Subject: Urgent Field Safety Notice Software Update – Minute Ventilation Sensor Software Update Available for Pacemakers (see previous communication issued in December 2017 with reference 92186345-FA).

Summary Field Safety Notice (FSN)

Boston Scientific Software Update for MV Sensor Oversensing

Figure 1. Summary dialogue presented at the next programmer interrogation after the MV sensor vector has been switched or MV disabled by the Signal Artifact Monitor.

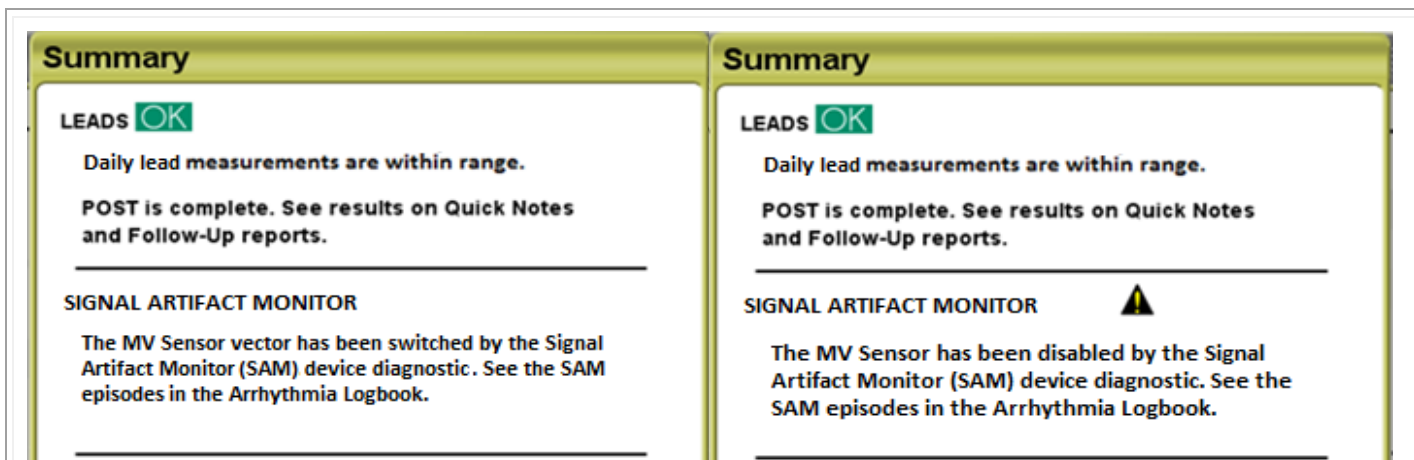
A disabled MV Sensor will remain in that state until manually reprogrammed. No MV rate-responsive pacing and no respiratory-related trending will occur while the sensor is disabled. At the next programmer interrogation, the user will be notified of any SAM events (see Figure 1) with associated episodes available within the arrhythmia logbook for review. A future LATITUDE NXT Remote Patient Management system release will enable the user to view SAM parameters/episodes and receive a yellow alert if SAM disables the MV sensor.
